**Independent Review of the  
Cleanup Plan for the East 115<sup>th</sup> Street  
Manufactured Gas Plant Site  
New York, New York**

**Peter M. Strauss  
PM Strauss & Associates**

**Lenny Siegel  
Center for Public Environmental Oversight**

**June 12, 2009**

### Extent of MGP Wastes (from Draft Decision Document)

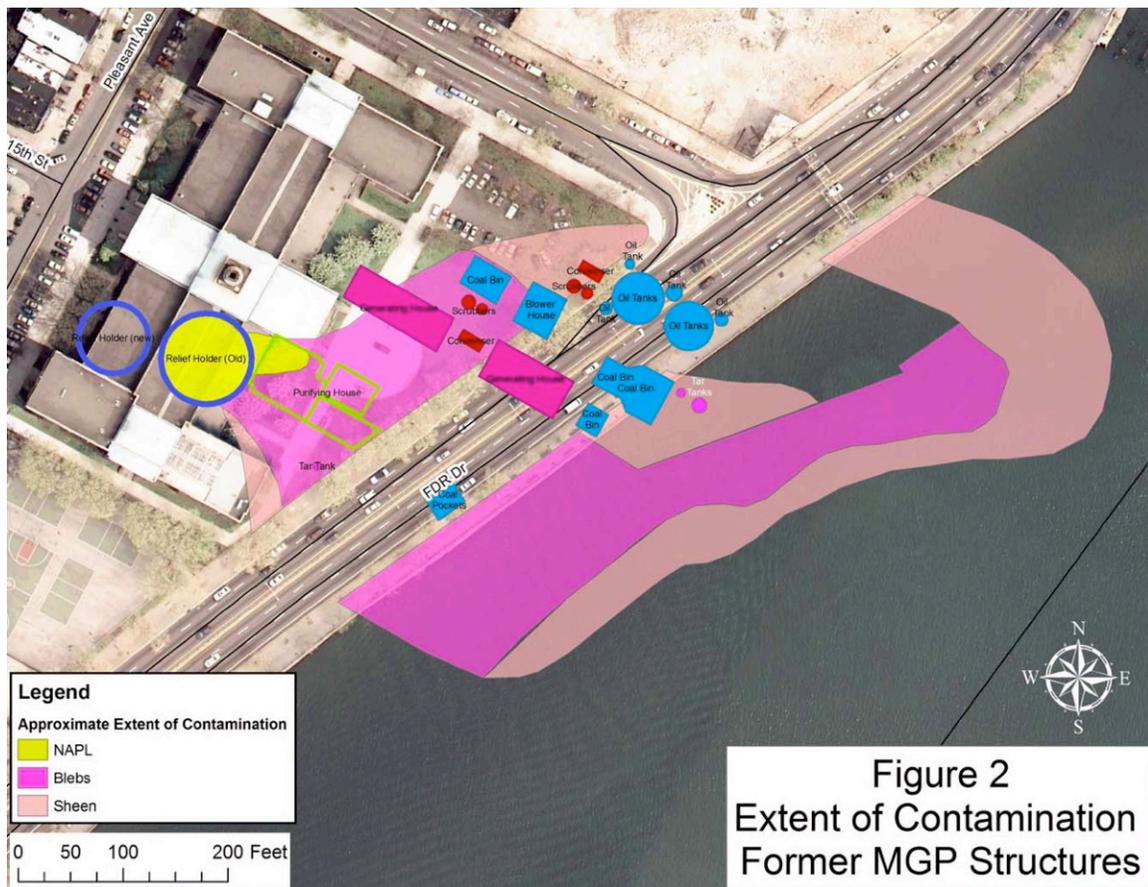
In numerous locations at the site the concentrations of contaminants in soil are well above DEC's health-based Recommended Soil Cleanup Objectives (RSCOs), both at the surface and below the surface. In several sections of the AAR and other background documents, it is stated that the concentrations of contaminants were typical of urban fill in New York City, or that they appear to be related to urban background conditions not related to former MGP operations, although contaminants may be the same as those associated with MGP operations. This suggests that schoolchildren who are attending the two schools are not entitled to the same level of environmental protection as students attending schools elsewhere. We are not advocating that the grounds or the air be cleansed to pristine levels, but we do think that Con Ed and the DEC have an affirmative duty to demonstrate that the school environment is as protective as it practically can be.

**Proposed Excavation Triangle and Barrier Wall**

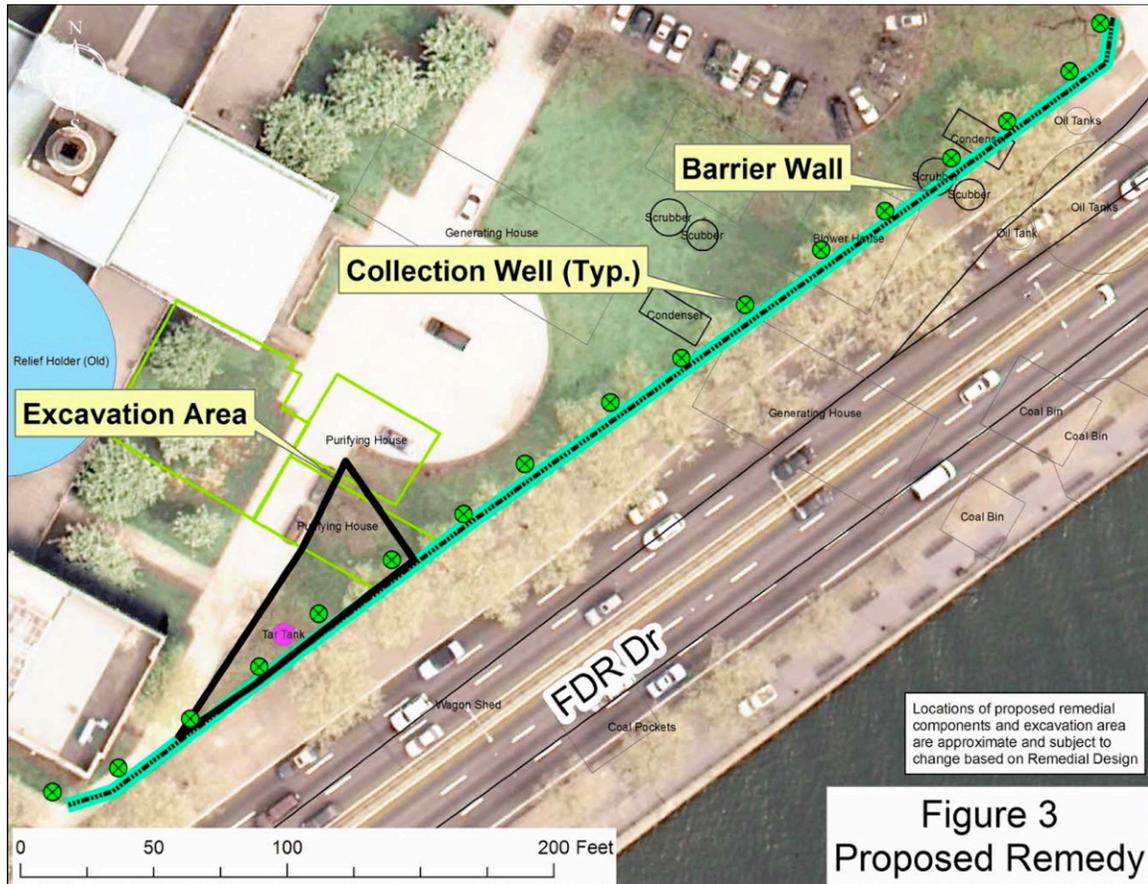
Con Ed proposes only to excavate a small triangle on the southeastern portion of the school property. Its boundaries were defined for the most part by Test Pits 3 and 4, which were examined during the Remedial Investigation (RI) phase. These found debris together with what appeared to be some purifier waste (Pit 3). Olfactory observations and Photo Ionization Detector readings from both pits indicate the presence of staining, sheen, globules, or NAPL as high as eight feet from the surface. We concur that this area needs to be further delineated before excavation proceeds, and a rigorous protocol of confirmatory sampling needs to be performed to demonstrate that no NAPL exists above the water table at this location.

The proposed excavation triangle seems arbitrary, and DEC appears to agree. In the Draft Decision Document it states, "The proposed excavation area will be further defined by test borings and/or test pits as part of the remedial design, and will be extended as dictated by this delineation." **If so, strict removal criteria need to be established prior to excavation, focusing on the levels of contamination and their proximity to the surface. We suggest that coal tar be investigated to eight feet below the surface, and if found, either in globules or staining, that it be removed.** These criteria should be contained in the Final Decision Document as performance objectives.

More specifically, Test Pit 2 in the south courtyard was only completed to a depth of approximately five feet. It was close to the building foundation, and excavation stopped because it hit debris. It was located in the vicinity of the purifier house, and some spent purifier wastes, but no cyanide, were found. Soil borings in this vicinity showed fairly high levels of PAHs. At Test Pit 5, which is located to the east of the outside wall, excavation was also stopped before it hit the water table, because of debris. Excavation up to that point indicated fairly high levels of PAHs, exceeding RSCOs. Soil borings in the area also had high levels of PAHs. **We recommend that the areas around Test Pit**

2 and Test Pit 5 undergo further investigation and any contamination (down to approximately eight feet) be removed.
